ARCHITECT'S SUPPLEMENTAL INSTRUCTIONS

PROJECT:	Lee Lofts II – Tenant Space 2 Offices Salina, Kansas	Report No.	One (1)
OWNER:	Overland Property Group Dan Maximuk 234 N. Santa Fe Ave, Suite A Salina, KS 67401	Date	Oct. 14, 2024
CONTRACTOR:	MCP Group 3501 SW Fairlawn Rd. Topeka, KS 66614	Architect's Proj No.	24-3420
		Contract For:	General Construction Mechanical, Electrical

M1.2

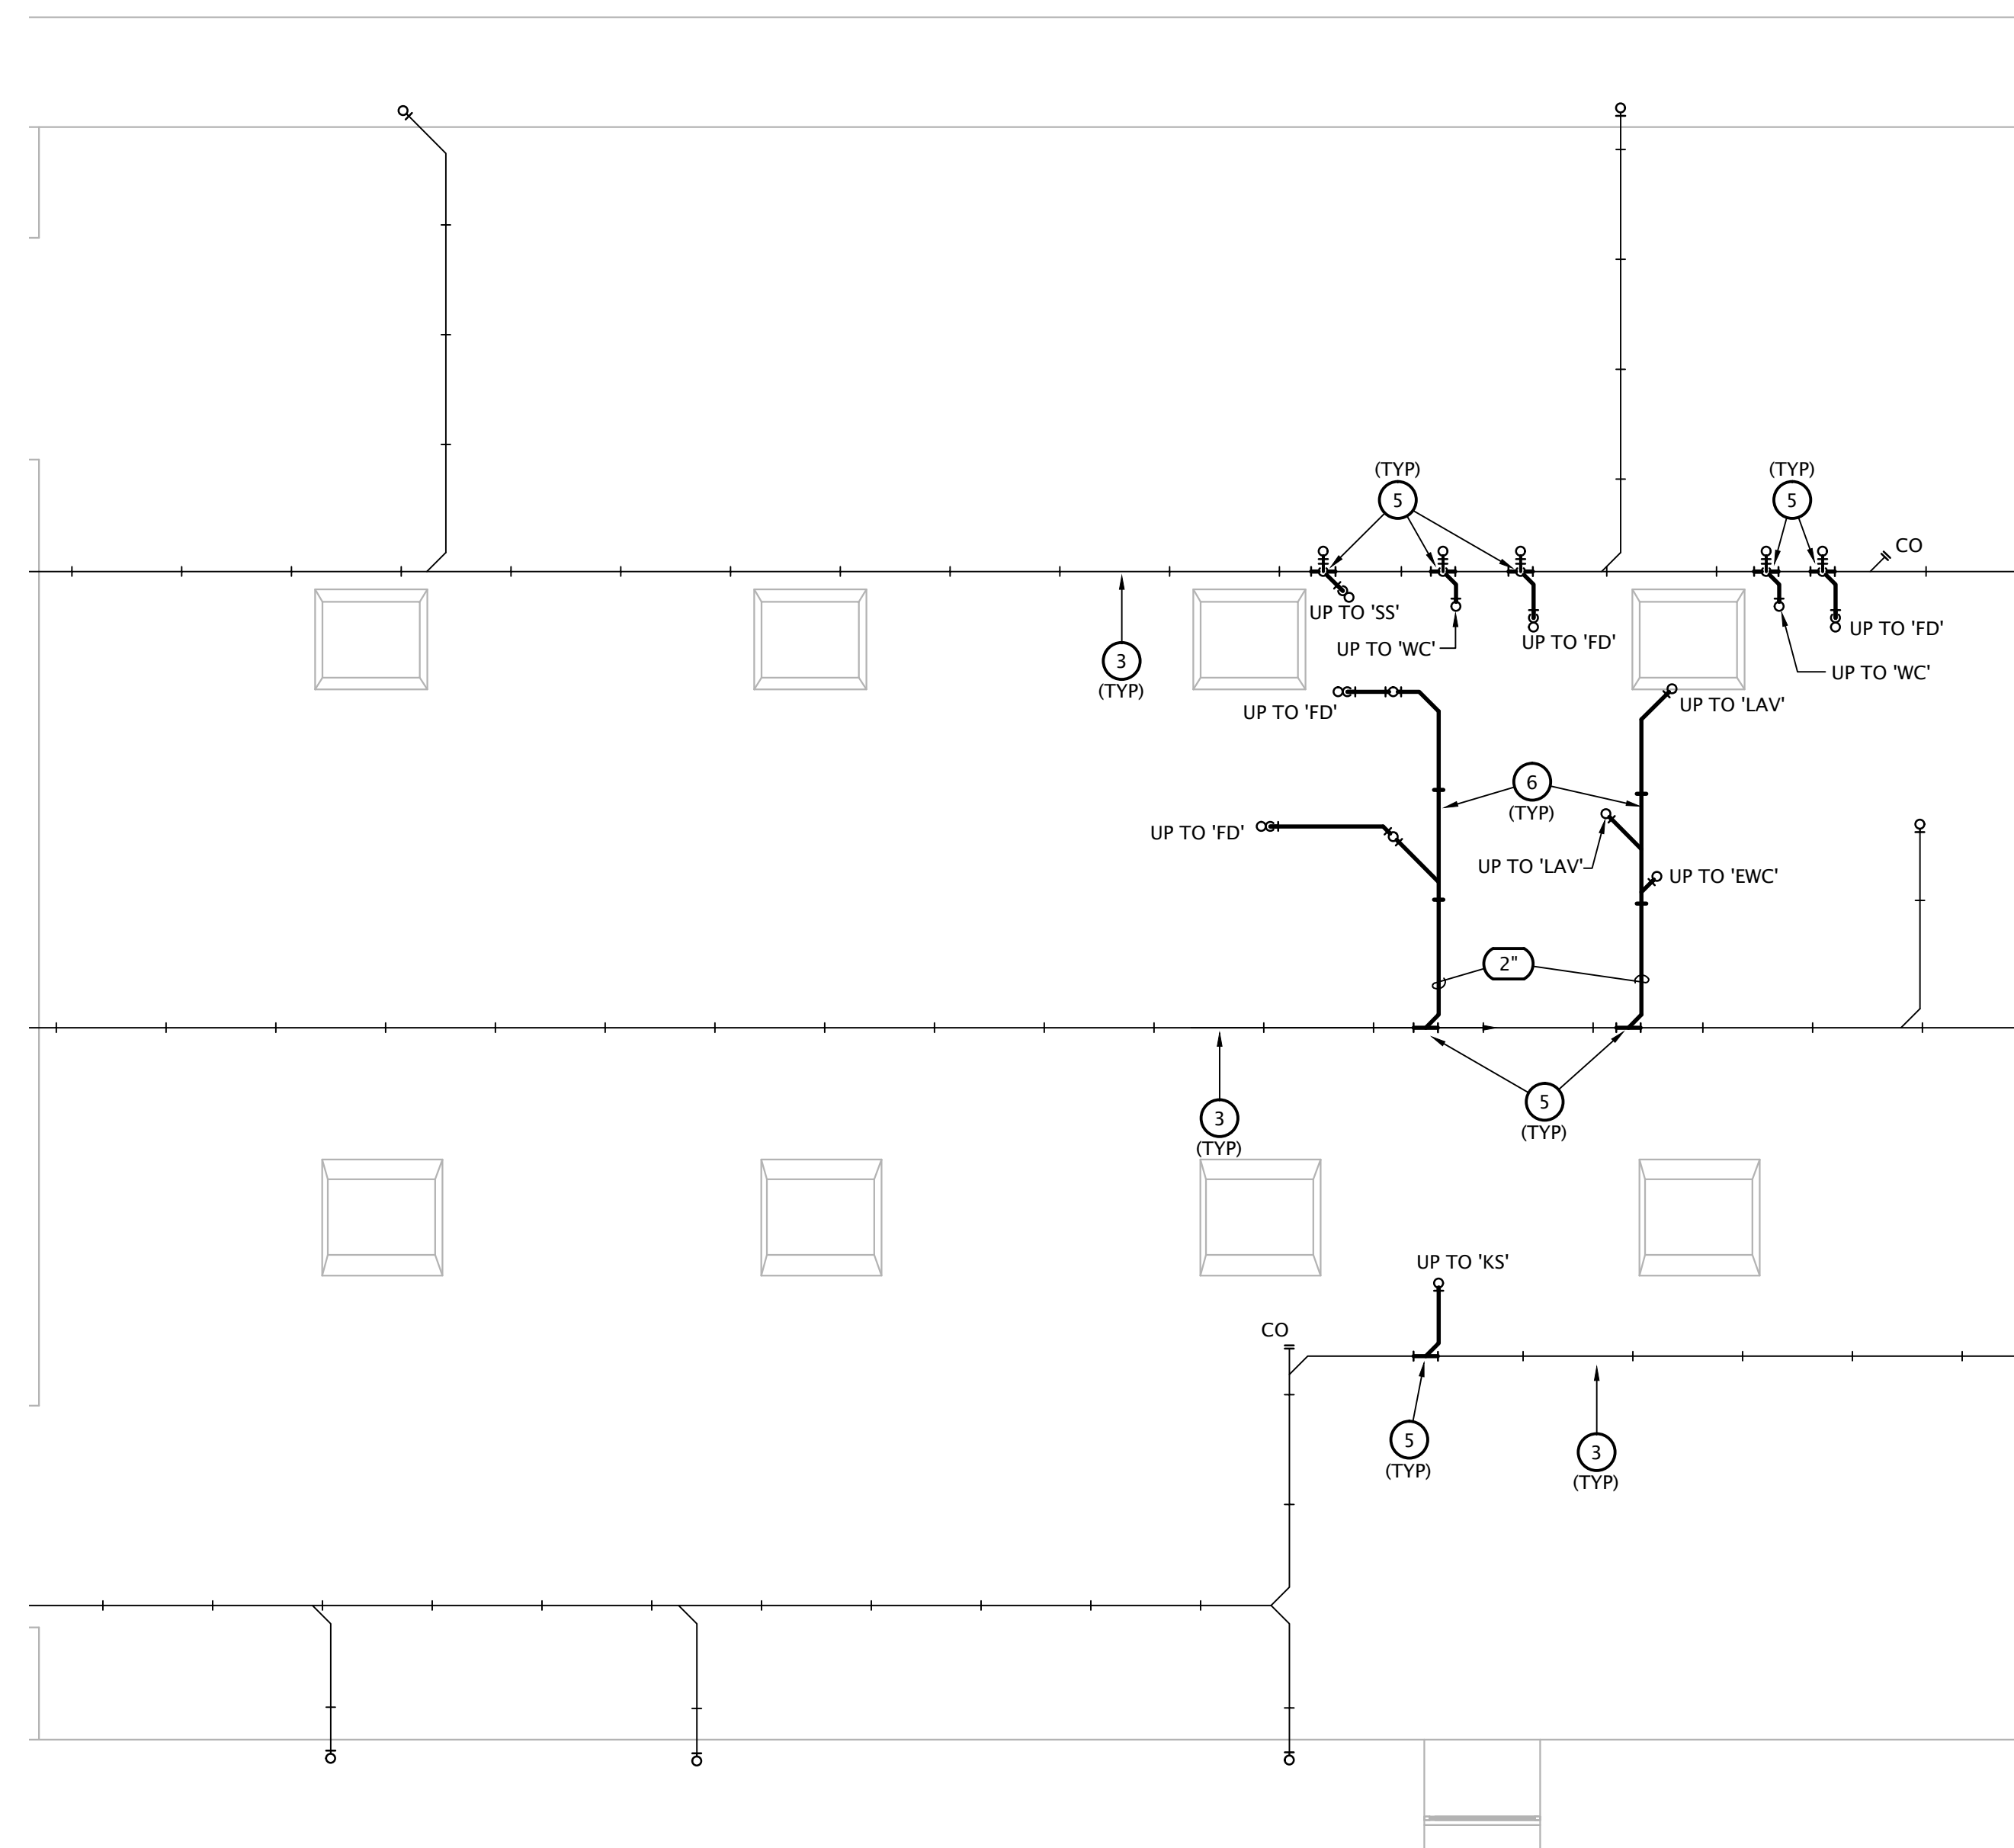
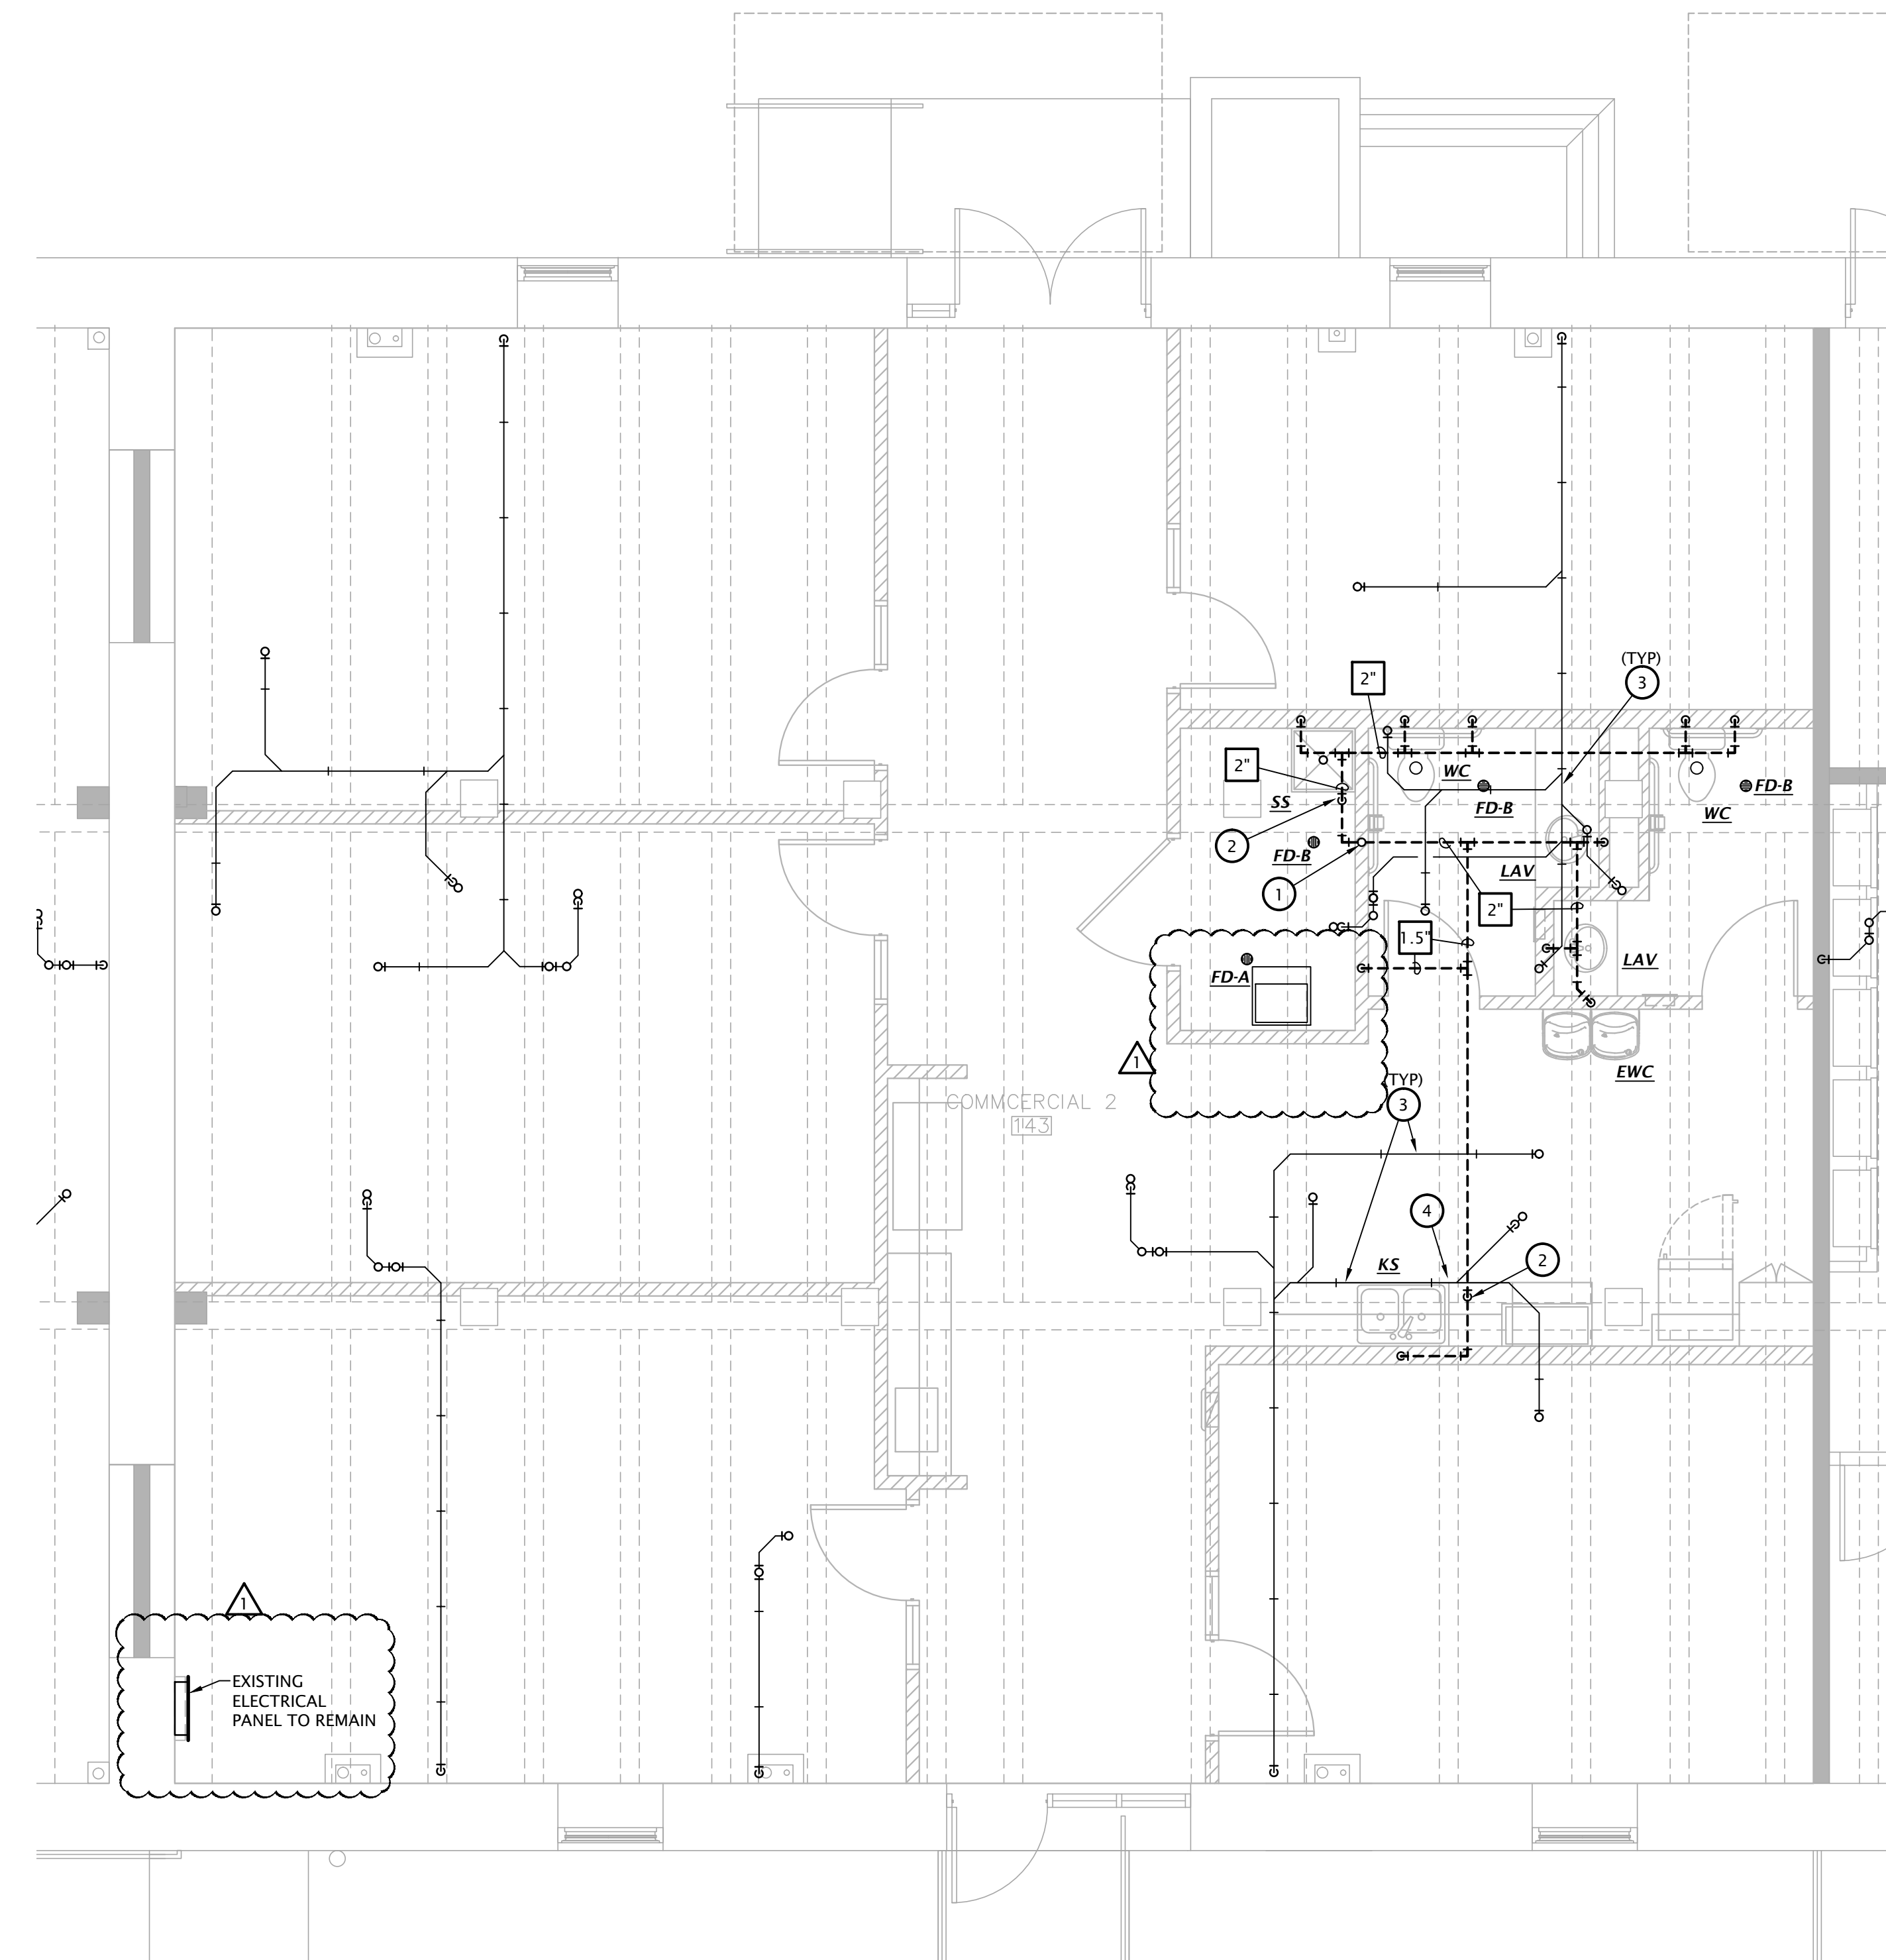
- e. Sheet M1.2 and M1.3 – revised for modification to mechanical closet size and electrical panel is to remain in existing location.
 - f. Sheet E1.1 – revised to show condensing unit to grade, modifications to mechanical closet size and show existing panel 'C2' as existing to remain.
